Title: **Stage 1 Quality Audit,**
For;
Proposed Residential Development, Confey, Leixlip, Co.
Kildare.

Report reference: **3139R01**

St 1 RSA & QA – Residential Development, Confey, Leixlip

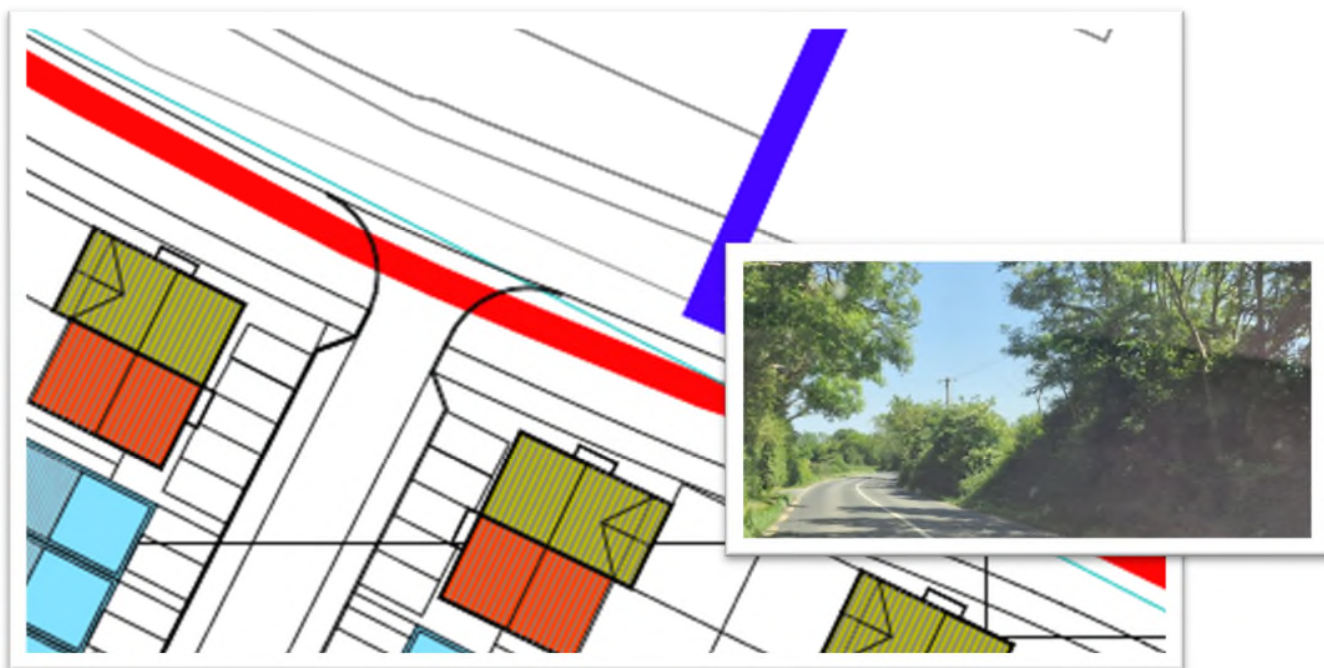
4.1 Problem

It is proposed to provide a footpath along the R149 to the site boundary. There is no footpath to join with at the G.A.A. grounds to allow pedestrians travel onwards to Captain's Hill. This could lead to pedestrians having to travel in the carriageway where they could be struck by passing vehicles.

It is recommended that a continuous footpath be provided to join with the footpath which starts at the traffic signals on Captain's Hill.

Paragraph No. in Safety Audit Report	Issue accepted (yes/no)	Recommended measure accepted (yes/no)	Alternative measures (describe)	Alternative measures accepted by Auditors (Yes/No)
4.1	Y	Y - these lands are not within the applicants control, however this footpath is to be made continuous as part of the R149 upgrade works.		
4.2	Y	Y - visibility splays to be cleared.		
4.3	Y	Y - visibility splays to be cleared.

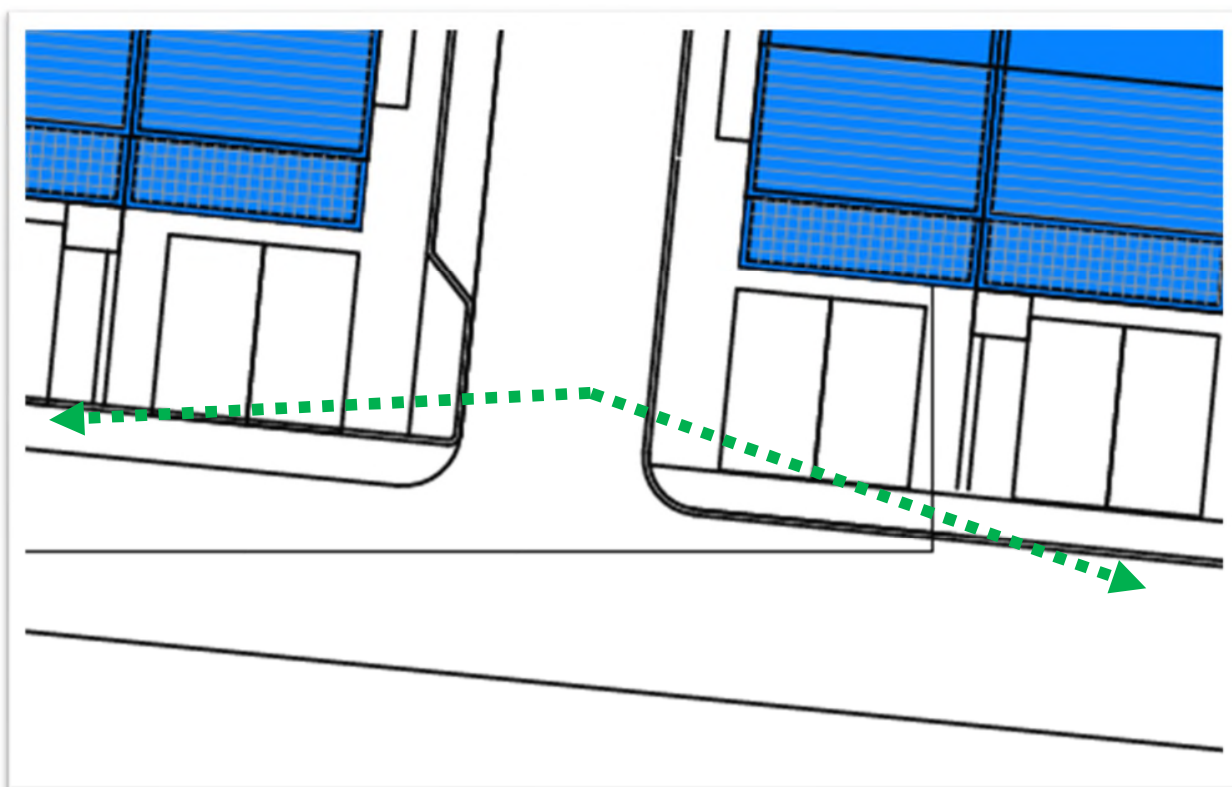
4.2 Problem

It is unclear if the boundary hedging/trees are to be removed as part of the development works. Without adequate clearance, visibility for drivers exiting the development would be limited by that vegetation and could result in side-impact or rear-ends collisions.

It is recommended that the visibility splays be kept clear of obstacles.

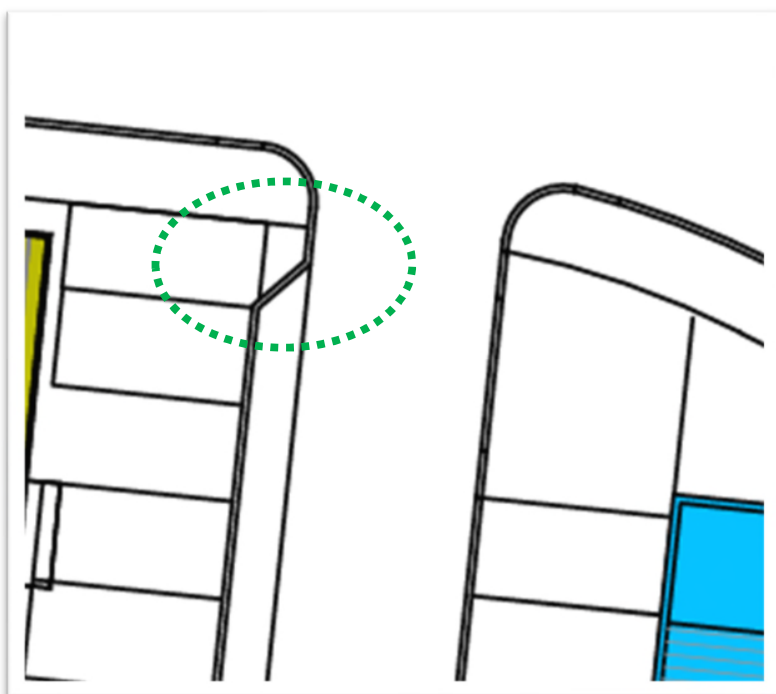
4.3 Problem

Car parking spaces may obscure visibility at internal junctions. This could lead to side-impact or rear-end collisions.

It is recommended that the visibility splays be kept clear of obstacles and that the stopping sight distance envelopes at sharp bends be kept clear of obstacles including parking spaces and boundary hedging/fencing.

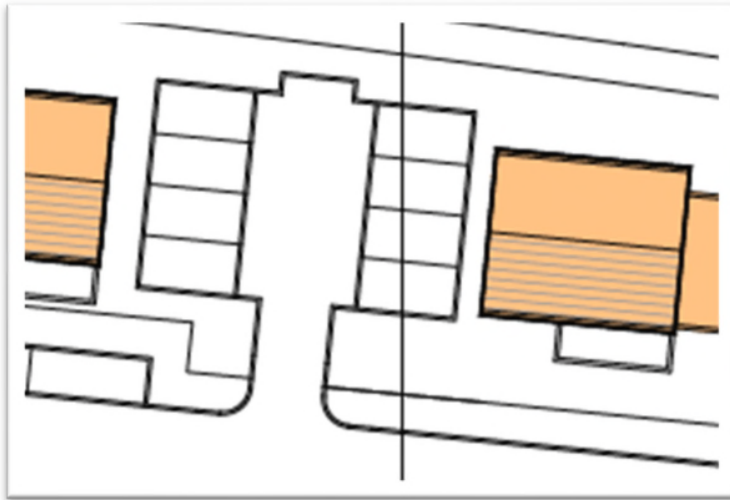
5.1 Issue

The footpaths do not appear to be continuous on some internal roads. This could lead to pedestrians having to step into the carriageway.

It is recommended that continuous footpaths be provided.

Paragraph No. in Quality Audit Report	Problem accepted (yes/no)	Recommended measure accepted (yes/no)	Alternative measures (describe)	Alternative measures accepted by Auditors (Yes/No)
5.1	Y	Y - this is a 1.2m wide step in space on a shared street.		
5.2	Y	Y - spaces are 5m deep and aisle is 6m wide.		
5.3	Y	Y - swept path analysis will be carried out and any amendments required implemented.		
6.1	Y	Y - areas to be adjusted to suit.		
6.2	Y	Y - will be reviewed at detailed design stage.		
6.3	Y	Y - footpath links will be provided where levels are acceptable.		
7.1	Y	Y - cycle facilities will be provided as part of the R149 upgrade works.

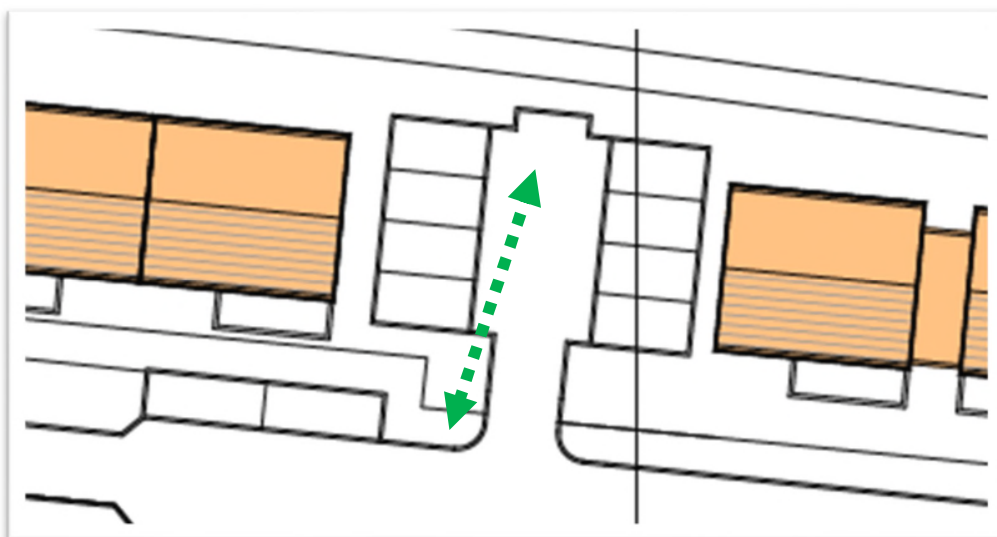
There are a number of tight radius bends and traffic calming buildouts throughout the scheme. There is a risk that refuse vehicles or emergency vehicles may not be able to undertake some manoeuvres without mounting the footpaths and putting pedestrians at risk.

It is recommended that a swept path analysis be carried out to ensure such movements can be readily carried out.

Problem Location Plan.

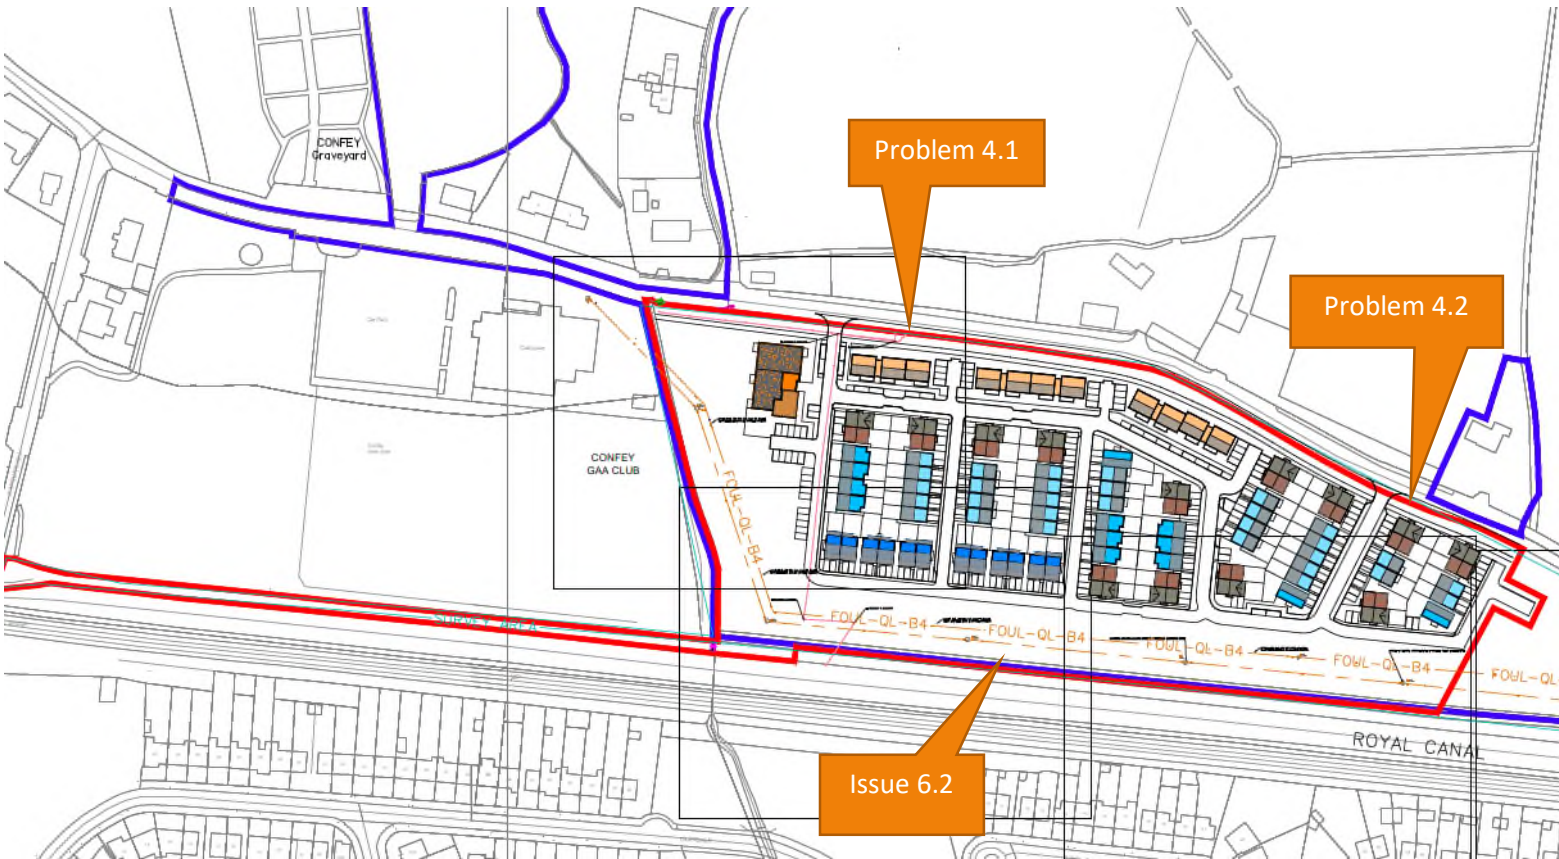
Other problems and Issues are general issues throughout the scheme
